**State Water Resources Control Board  
Eagle Mountain Pumped Storage Project  
(FERC Project No.13123)**

**Responses to Comments on July 2010  
Draft Environmental Impact Report (SCH #2009011010)**

**January 2013**

**Package 5 of 6**

Figure SC-1: Aerial Overview of Project Area and Proposed Project Features, indicating viewpoint locations at higher elevations within National Park Boundaries. Green lines indicate the JTNP boundaries.

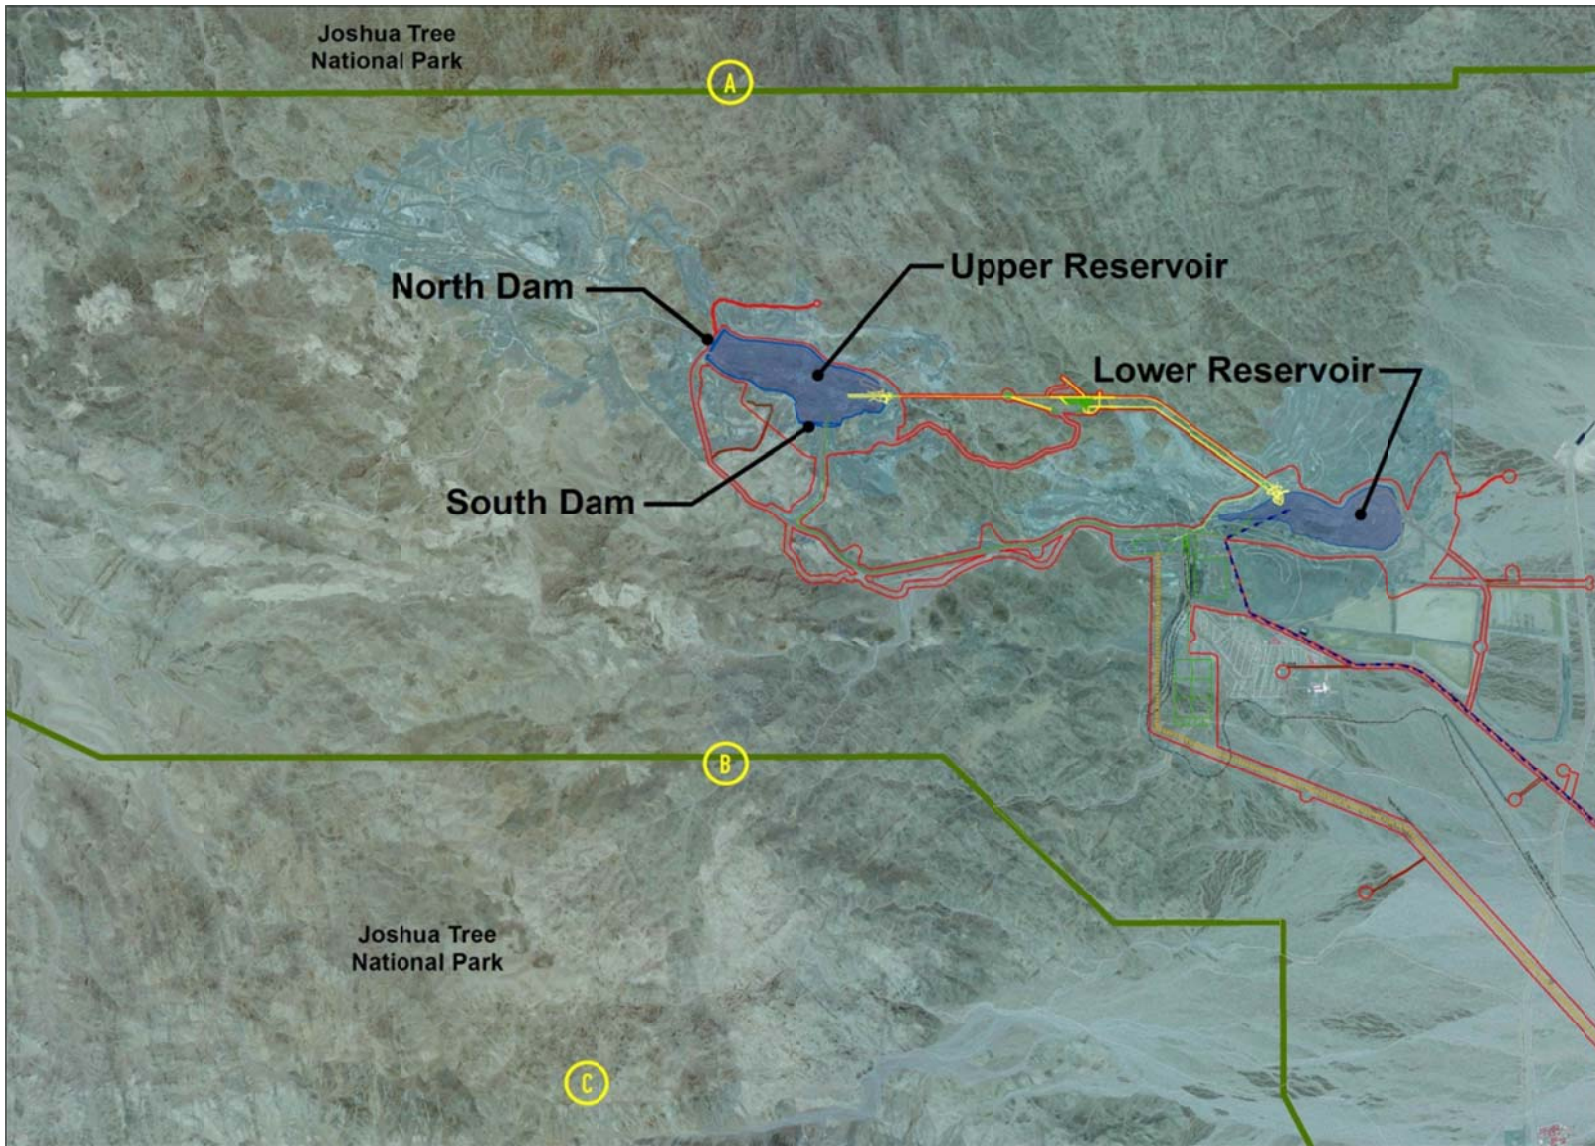
**SC #11:** The DEIR contains this statement: “Hikers on surrounding ridge tops within the JTNP and Wilderness Area may view some of the Project features (mainly reservoirs and dams) which would be within middle ground distance zones (see Figure 3.10-8 in Section 3.10 Recreation). Access to these ridge tops is very difficult and viewer numbers are low.”

**Response to SC #11:** The baseline condition of the Central Project Area, where the reservoirs and powerhouse will be located, is of a highly disturbed area that in no way resembles a natural or wilderness setting. The Project will not change the character of the landscape in a significant manner, since the majority of the landscape is currently a large scale open pit mine with associated tailing piles.

Please refer to Figures SC-1 through SC-4, which illustrate representative views from several ridge tops located within the Joshua Tree National Park’s (JTNP) boundary nearest to the Project site. Viewers accessing these ridge tops will observe features located outside JTNP’s boundaries, including some of the Project features. These proposed features will be visible within an existing setting that is disturbed by open pit mine tailings, and other features associated with past mining activity. As noted previously, these Project features are all located outside of the JTNP boundaries, and while the reservoirs represent a change in visual character, the change is insignificant within the context of the mine. These viewpoints that may allow detection of the Project are located in a remote and difficult-to-access portion of the JTNP. Minimal visual alteration may be experienced by a small number of visitors, but the change must be viewed in the context of the extremely modified landscape in the area.
